Reference: Engineering Services
Smith Garage
Project No.: DRB2301-0387-A

1. Stem wall foundation in-lieu of the plan specified monolithic slab.

FOUNDATION PLAN

FOUNDATION PLAN

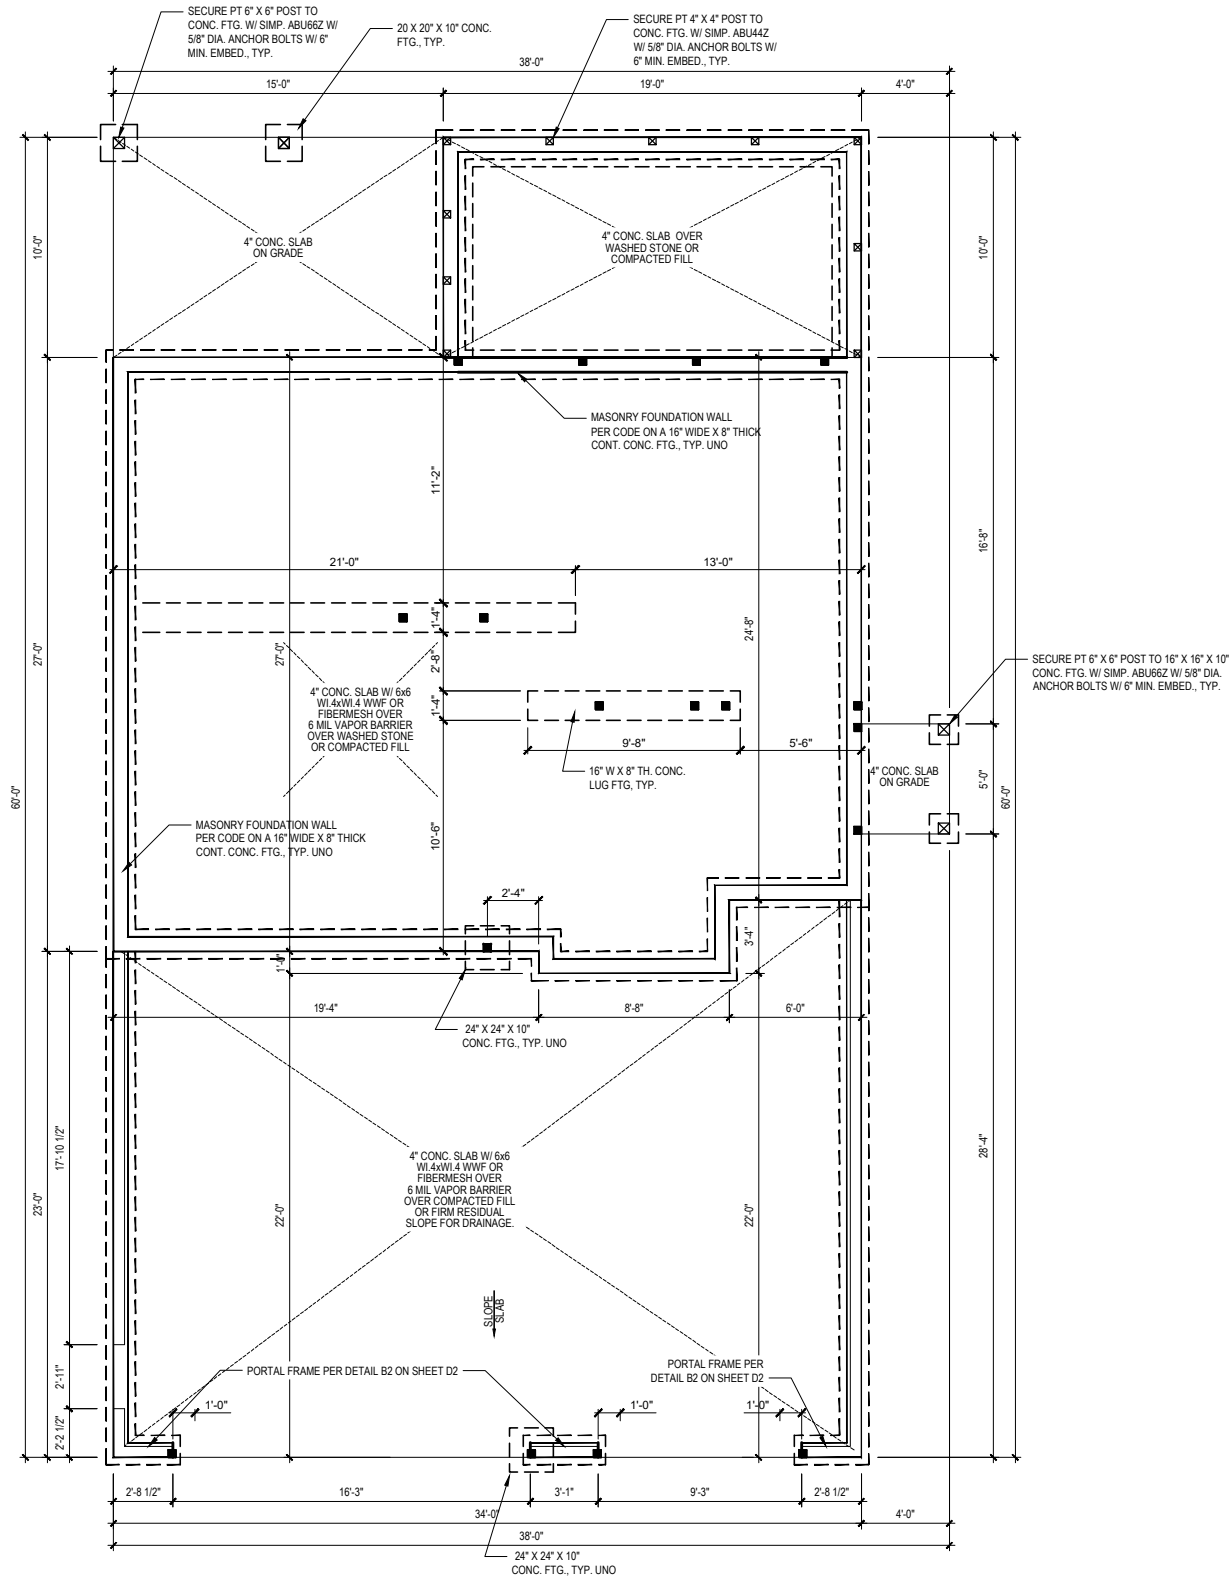
1. Based on our plan review and analysis, the proposed stem wall foundation should be constructed in general accordance with the attached diagrams on sheet 2 and 3 of this report.

REVISIONS		
No.	Date	Remarks
1	8-25-24	Stem wall Foundation
